Access Compliance Report

Public Rights-of-Way

(Curb Ramps)

Intersection ID: N/A	Main Street: NORTHLAKE CENTRE PY	Cross Street: N/A	Location: SE
ADA ID: 92B166388904	Ramp Type: PerpDiag	Initial Pass/Fail: Fail	Overall Compliance: No
Codes/Mitigation Info/Possible Solution		Field Measurements/Component Compliance	
Severity Score: 8.75

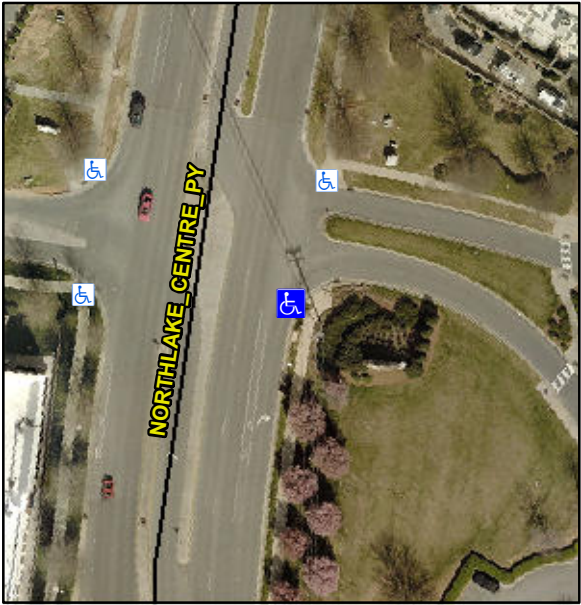
Possible Solutions:		Compliance	Description	Data	Compliance	Description	Data
	Remove & Replace Curb Ramp With Two New Directional Ramps or Equivalent.		N/A	Ramp Length (in)	51.0	Yes	Ramp Slope (%)	5.2
			No	Ramp Width (in)	45.5	Yes	Ramp XSlope (%)	1.6
			N/A	Flare Type LT	N/A	N/A	Flare Type RT	N/A
			N/A	Flare Slope LT (%)	N/A	N/A	Flare Slope RT (%)	N/A
			N/A	Flare Traversable LT?	No	N/A	Flare Traversable RT?	No
			N/A	Landing Length (in)	N/A	N/A	DWS Provided?	N/A
			N/A	Landing Width (in)	N/A	N/A	DWS Contrast?	N/A
			N/A	Landing Slope (%)	N/A	N/A	DWS Length (in)	N/A
			N/A	Landing X Slope (%)	N/A	N/A	DWS Full Width?	N/A
			N/A	Landing Curb? (Y/N)	N/A	N/A	DWS Offset (in)	N/A
			N/A	Shared Landing?	N/A			
			N/A	Gutter Ponding?	N/A	N/A	Gutter Slope (%)	N/A
			N/A	Gutter Lip Ht (in)	N/A	N/A	Gutter X Slope (%)	N/A
			N/A	Painted X Walk1?	No	N/A	Painted X Walk2?	No
				X Walk 1 Direction	To NE		X Walk 2 Direction	To NW

N/A	X Walk 1 Width (in)	N/A	N/A	X Walk 2 Width (in)	N/A
				X Walk 1 Slope (%)	3.2		X Walk 2 Slope (%)	2.8
				X Walk 1 X Slope (%)	3.1		X Walk 2 X Slope (%)	3.1
			N/A	Ramp inside XWalk1?	N/A	N/A	Ramp inside XWalk2?	N/A
Surveyor Notes: N/A PROW/ADA: R304.5.1				Road Slope (%)	0.1	N/A	Clear Space?	N/A
				Road X Slope (%)	4.3	N/A	Clear Space to XWalk (in)	N/A
			N/A	Any Obstructions?	N/A	N/A	Storm Grate/Utility Hazard?	N/A
				Obstruction Type			Storm Grate/Utility Type	
						N/A		N/A
						Yes	Surface Condition? (G/P)	Good
Total Cost:		\$ 3200.00
